Access Compliance Report Public Rights-of-Way (Curb Ramps)

Main Street: BROADWAY Cross Street: S_ROSEBAY_ST Location: SE

ADA ID: RPRK220224154037 Ramp Type: Type 3 - Combination 1 Initial Pass/Fail: Fail Overall Compliance: No Severity Score: 2

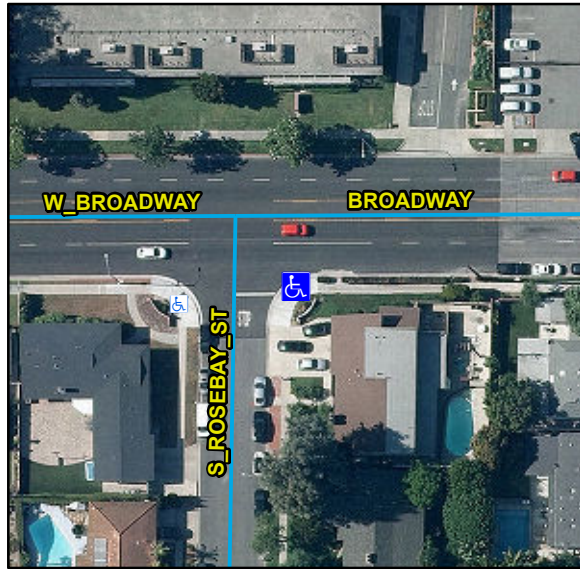
R304.5.3, STD 1115

Remove & Replace Curb Ramp With Two New Directional Ramps or Equivalent.
